AES Indiana appreciates the opportunity to respond to stakeholder comments submitted in response to the 2022 Integrated Resource Plan. The attached response addresses some of the key topics raised.

## AES Indiana's Reply to Stakeholders' Comments to AES Indiana's 2022 Integrated Resource Plan

June 9, 2023

**Figure 3. Corrected Annual Demand Response Savings by Bundle**

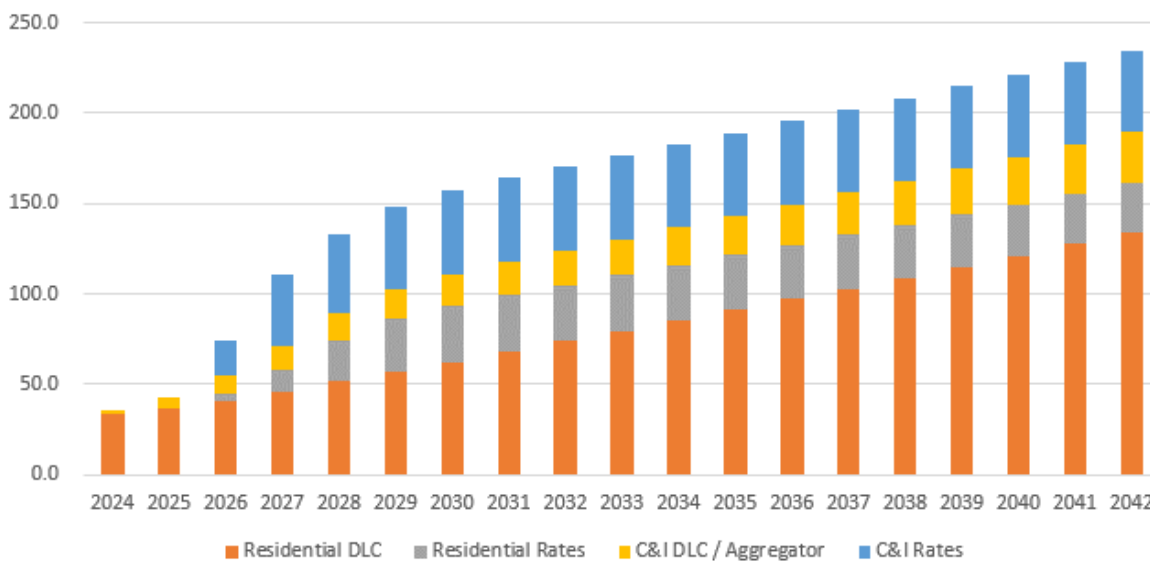
The CAC et al. notes on p. 18 of their comments that “Demand response bundles do not include residential space heating and water heating direct load control.”

The AES Indiana and GDS teams investigated the CAC’s comment and found that the Residential DLC bundle that was included in the IRP planning model did include direct load control of water heating; however, the water heating was errantly left out of the original table and corresponding chart in the Market Potential Study report (Figure 6-75 and 6-76 on pg. 118). This is likely the source of the CAC’s view that it was not included. The corrected table below includes water heating in the Residential DLC bundle.<sup>28</sup>

The demand response chart below has also been corrected to reflect the accurate numbers that were modeled in the IRP.<sup>29</sup>

<sup>29</sup> Correction of Figure 6-76 on p. 118 of [AES Indiana's 2022 IRP, Volume I](#).
